Toll Brothers

October 19, 2016

RE: RDCS20016-0015: Cochrane - Borello

THE ESTATES AT SAN SEBASTIAN
 ADDENDUM F1
 ORDERLY GROWTH & URBAN IN-FILL
 MORGAN HILL, CALIFORNIA
 FOR: **Toll Brothers**
Residential Development

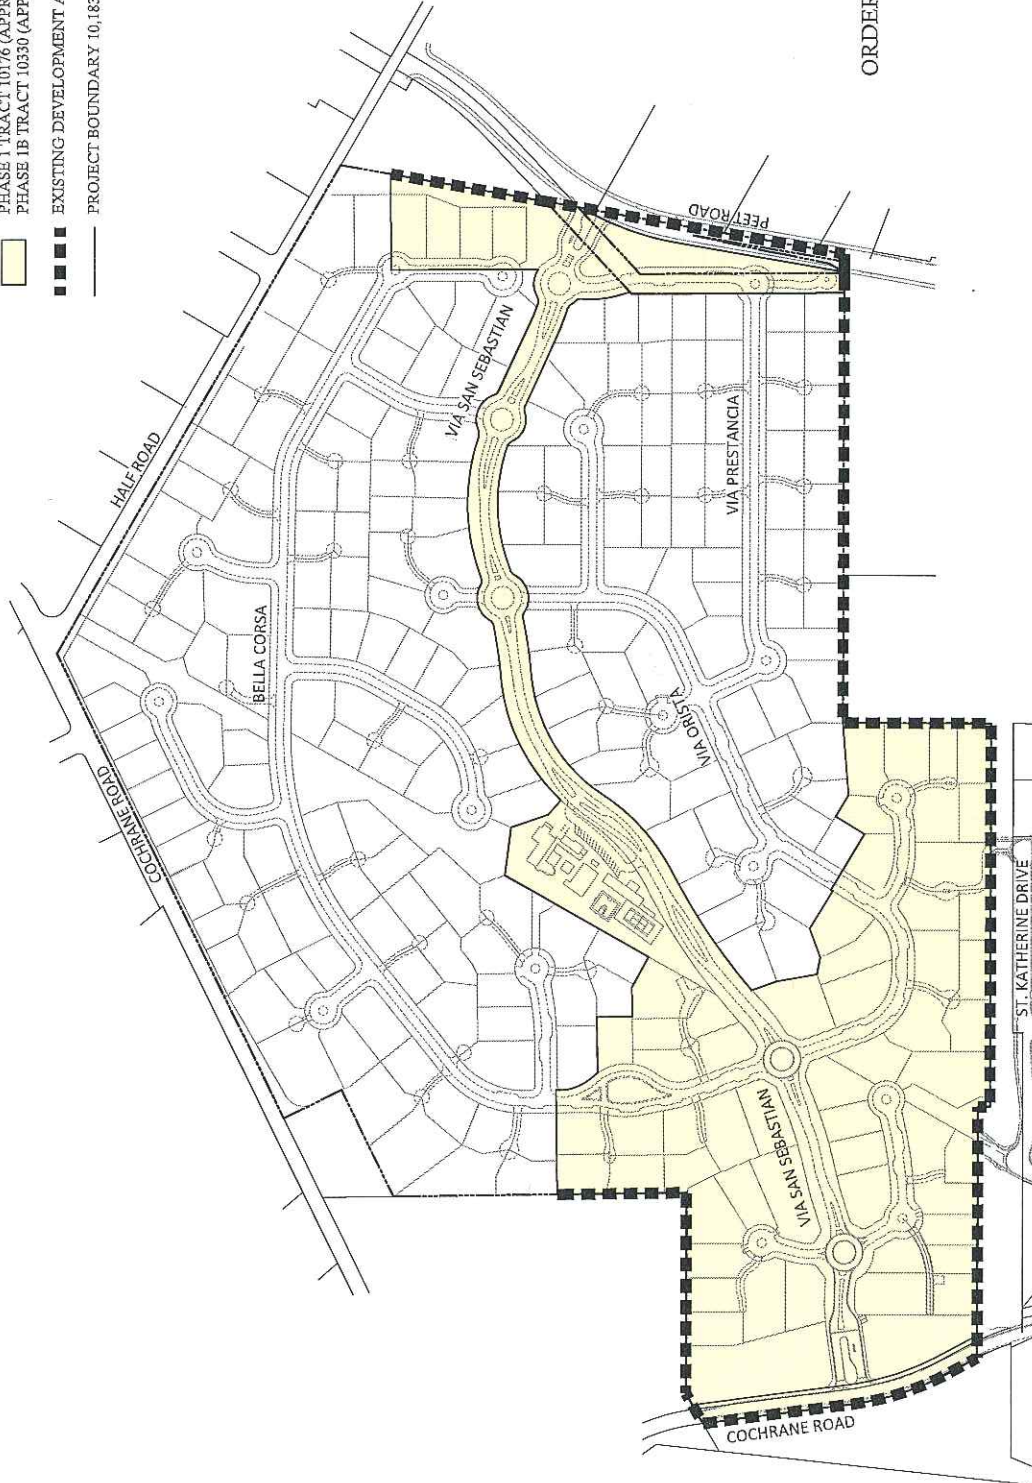
Alternatively, Addendum F1 calculated the adjacency, based on the entire 120-acre +/- project perimeter. Staff disqualified portions of the project boundary because they are adjacent to the City's Urban Growth Boundary. However, the criterion states that, "Where previously allocated phases of the same project have been developed or have received final map approval and are immediately adjacent to an otherwise undeveloped external boundary, that portion of the project's perimeter shall then be considered

developed...". The Applicant submits that those portions of the overall project boundary included in the approved Final Maps qualify as "developed", per the RDCS excerpt above. This interpretation would increase the adjacency to 61%, and result in a 4-point award.

THE ESTATES AT SAN SEBASTIAN
 ADDENDUM F2
 MORGAN HILL, CALIFORNIA
 ORDERLY GROWTH & URBAN IN-FILL
 FOR: **Toll Brothers**
 A Morgan Stanley Real Estate Company

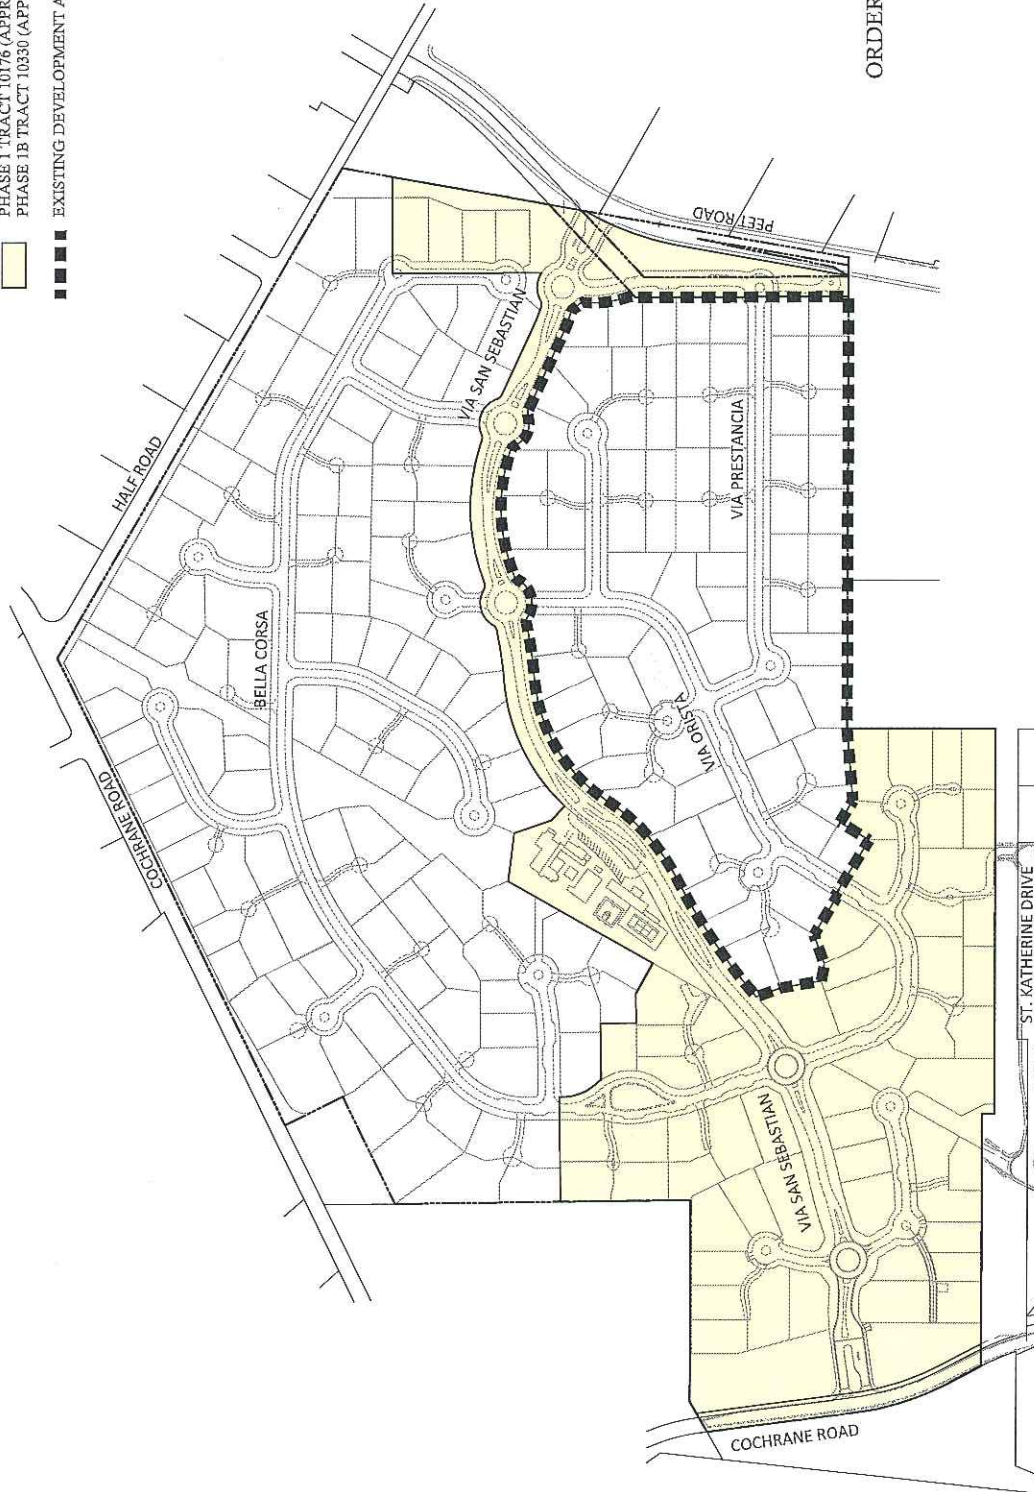
The Applicant submitted Addendums F1 and F2 (attached) with the RDCS Narrative. Each Addendum calculated the "developed" area by applying the description provided in the criterion. Addendum F2 delineates the next phase of San Sebastian's development, relative to adjacent "developed" areas. The entire perimeter of the future phase (4,900 lineal feet) is "developed", based on the disposition of off-site adjacencies and San Sebastian's Tract Map approvals. In this scenario, the project should be awarded 5 points for 100% adjacency.

THE ESTATES AT SAN SEBASTIAN
 ADDENDUM J
 PROPOSED STUBS FOR
 FUTURE DEVELOPMENT
 MORGAN HILL, CALIFORNIA

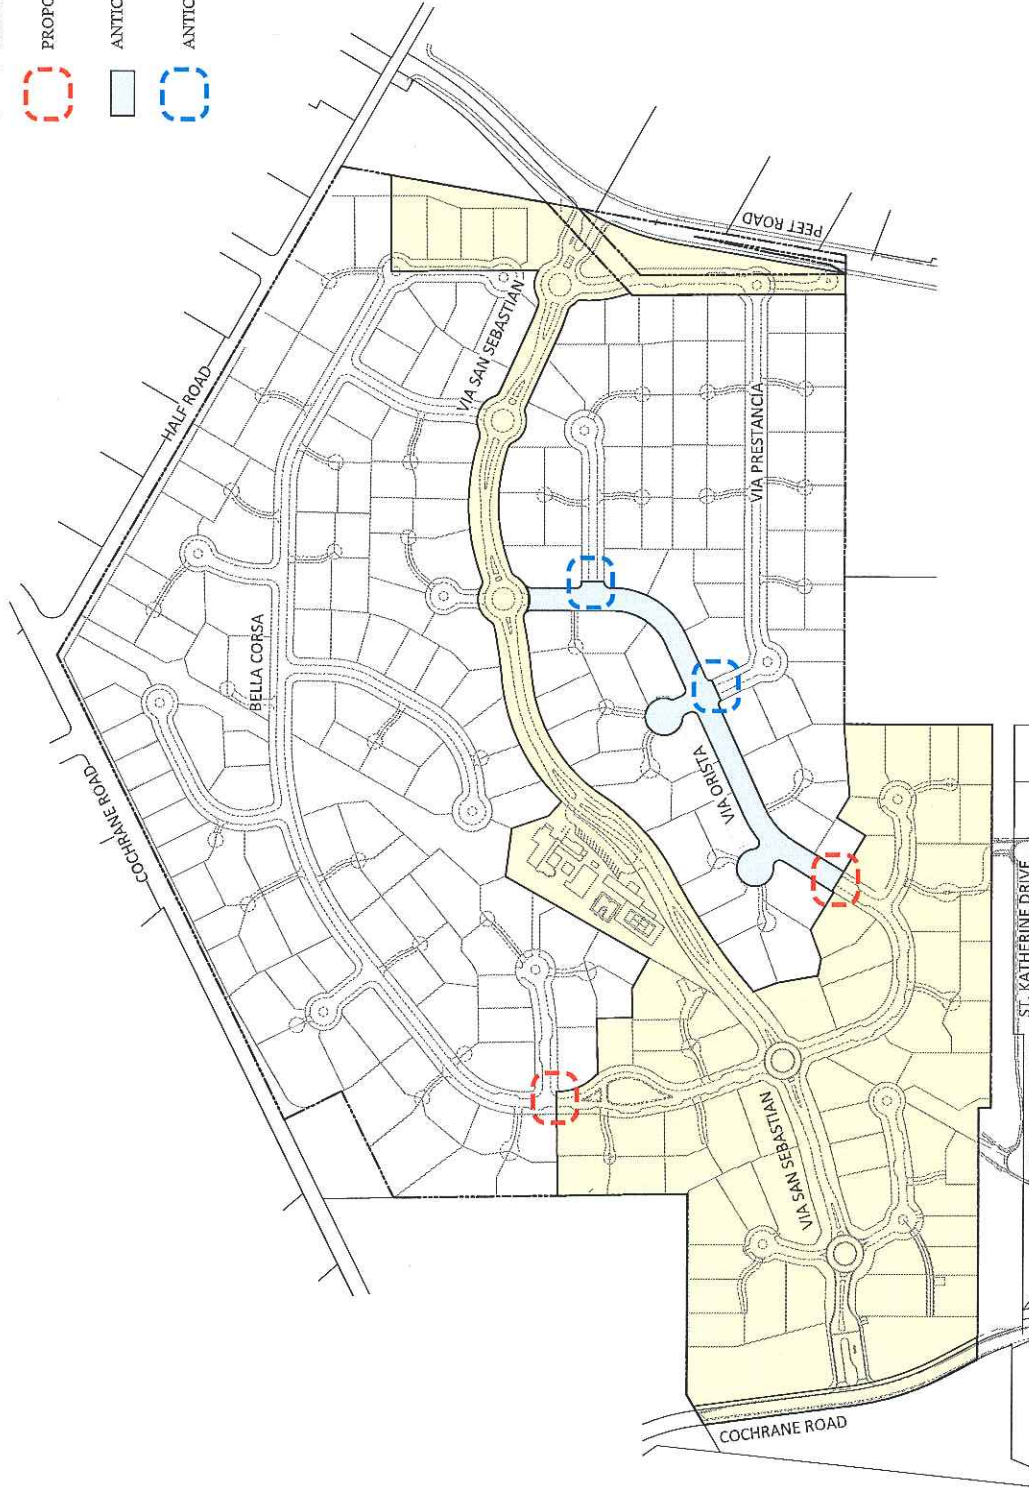
<u>Request 3.</u>		2016 RDCS		Narrative, Circulation B.2.b, page 57 of 80	
a.					
	The approved Tract Maps 10176 and 10330 has committed to short cul-de-sacs (54 lots). The Project is committing to short cul-de-sacs within the next phase of development. See Addendum J.		2	The project will create multiple cul-de-sacs including two that are greater than 400 feet in length.	0
b.

Prior to RDCS application submittal, the Applicant recognized that the project will not receive enough allocations in the 2016 RDCS competition to achieve full buildout. As such, the Applicant requested an allocation of up to 30 units, and submitted Addendum J (attached) to identify street improvements that would be associated with a 30-unit allocation award. Cul-de-sacs within the limits of this 30-unit application area do not exceed 400-feet in length.

Toll Brothers, Inc. respectfully requests **1 point** for avoiding cul-de-sacs greater than 400-feet within this phase.
